Protected Oak Tree Report and Review Letter

# Ladyface Vista

## Office Project

Subj: Ladyface Vista Professional Center (APN 2053-001-008) - Arborist Site Plan Review Letter

Attachment 1, Protected Tree Location and Project Impacts Map

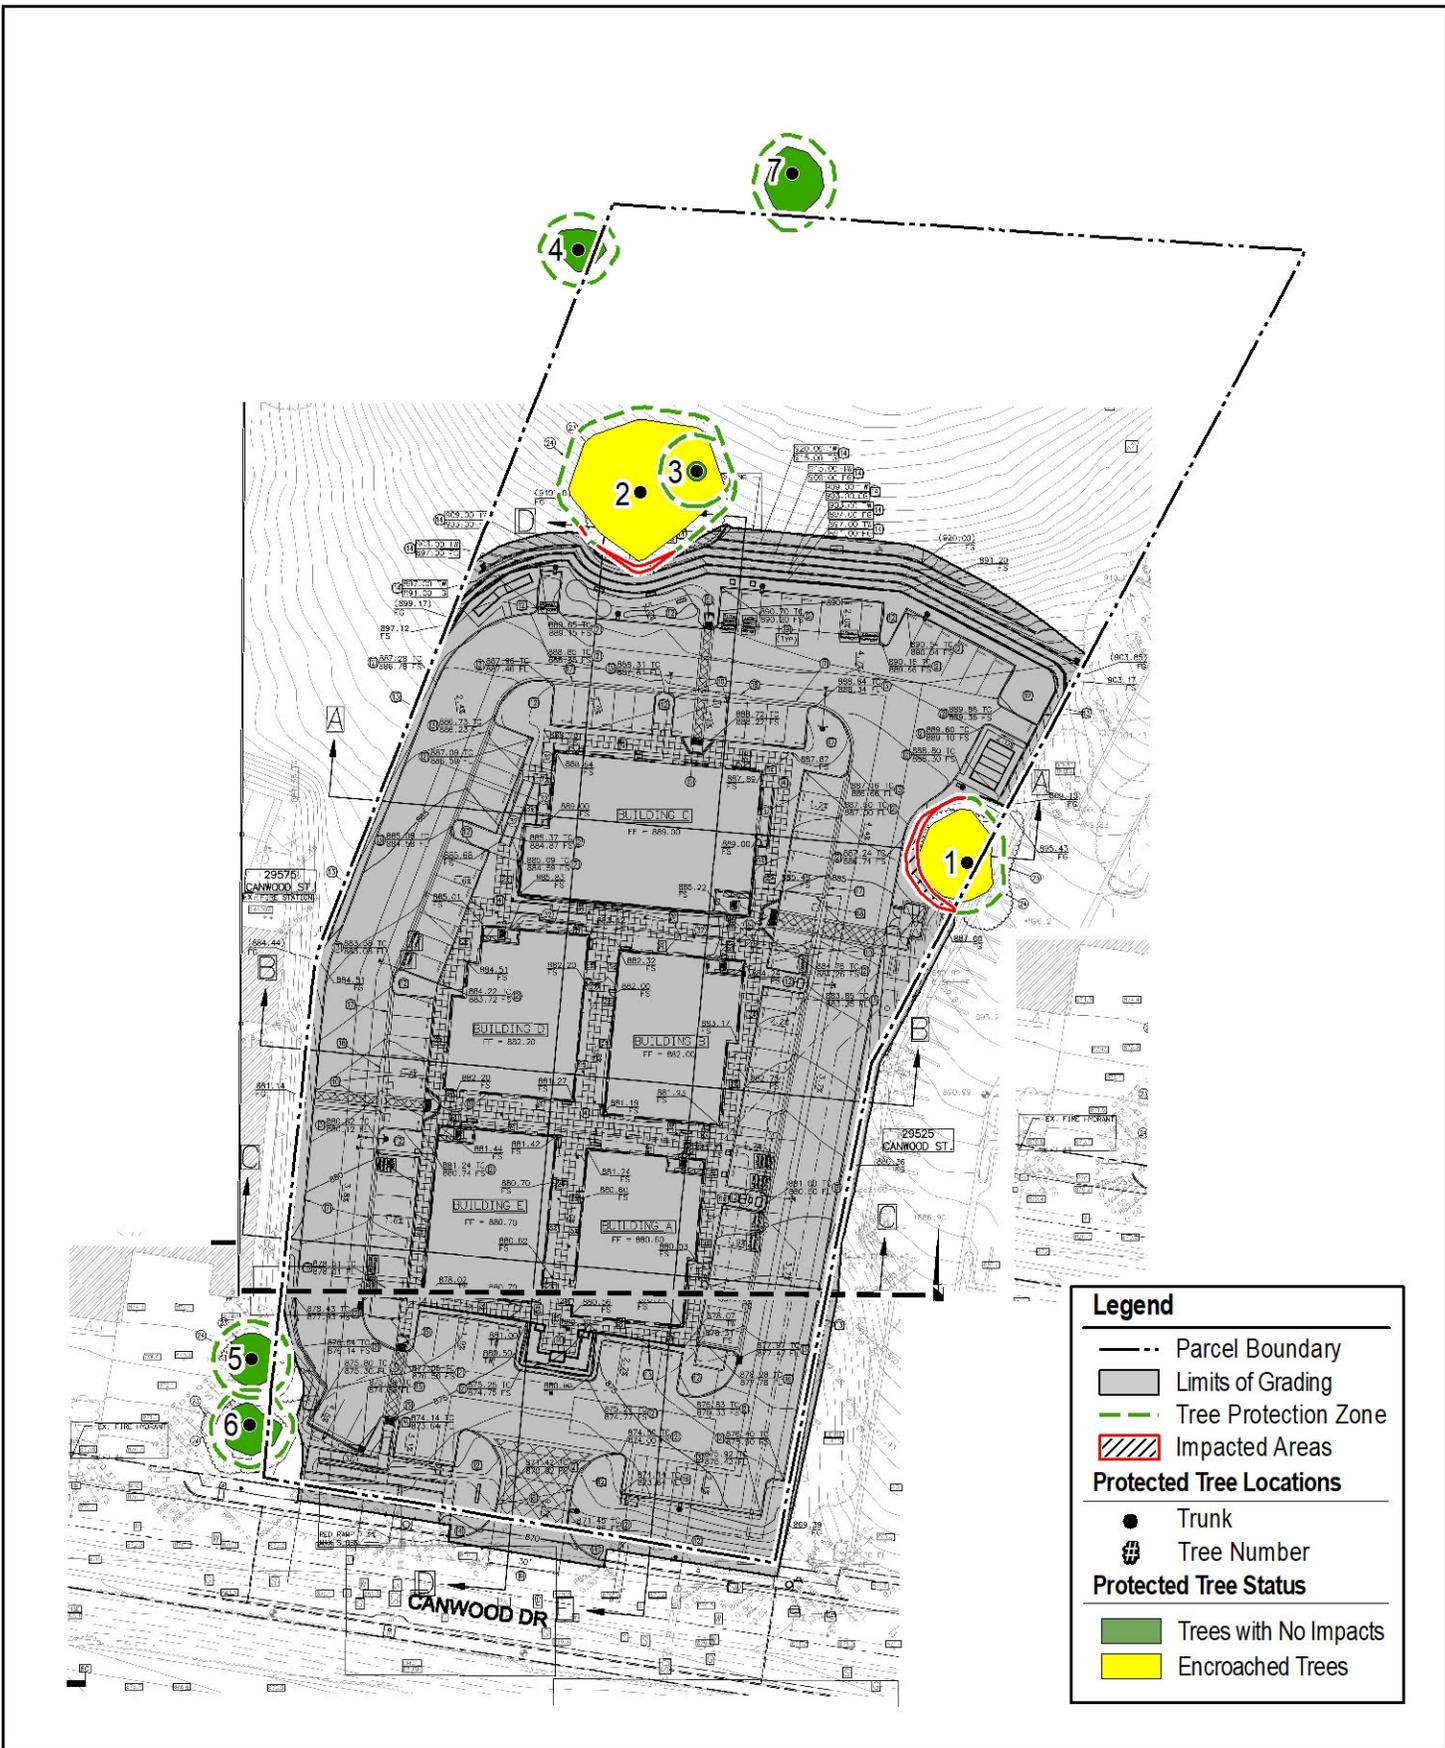
Based on the May 17<sup>th</sup> grading plan, Project construction will encroach into the protection zone (PZ) associated with two (2) protected oak (Tree #s 1 and 2) and allow for five (5) protected oaks (Tree #s 3, 4, 5, 6, and 7) to remain in place without being impacted. No protected oaks will need to be removed to allow for the development of this Project. These anticipated impacts are consistent with those discussed in the November 2, 2021 letter. However, the portions of the grading plan that have been updated within the proximity of onsite protected oak trees include the removal of the masonry retaining wall east of Tree #s 5 and 6 and the replacement of the masonry retaining wall along the northern portion of the site with a soil nail wall. A detailed discussion related to the PZ encroachments associated with Tree #s 1 and 2 are provided below.

It is anticipated that proposed activities associated with construction of the retaining wall along the eastern perimeter of the Project will encroach into the western portion of the PZ associated with Tree #1. As previously reported, it is anticipated that less than 1 linear foot (0.05 percent) of the canopy along the southwestern edge of Tree #1 will need to be raised to allow for equipment clearance during grading for the proposed retaining wall beneath this portion of the dripline. Because these activities will occur approximately 20 feet from the trunk, will impact approximately 12.1 percent of the PZ, and allow for approximately 99 percent of the existing canopy and grade beneath the dripline to be retained, these resulting PZ impacts are not anticipated to significantly affect the health of Tree #1.

It is anticipated that proposed activities associated with construction of terraced soil nail walls along the northern perimeter of the Project will encroach into 1 percent of the southern portion of the PZ associated with Tree #2. To construct each soil nail wall, 1- to 2-inch holes will be drilled at a 30-degree angle

approximately every 8-feet and a 20-foot steel rod or “nail” measuring  $\frac{3}{4}$ - to 1-inch in diameter will be inserted. Once the nail is inserted, the hole will be filled-in with grout. Lastly, once the installation of the soil nails are completed, shotcrete will be installed on the surface of each wall segment. Because the uppermost soil nail wall will be installed approximately 29 to 31 feet from the trunk and at existing grade, it is anticipated that the angle of the uppermost nail will result in the soil nail passing approximately 15- to 20-feet below the location of Tree #2’s trunk. Additional soil nails will not be placed above this point. Based on these assumptions, the terraced soil nail walls will allow for both the canopy and grade within the dripline to be retained and will not require the canopy to be trimmed or the roots to be removed. Therefore, the resulting PZ impacts are not anticipated to significantly affect the health of Tree # 2.
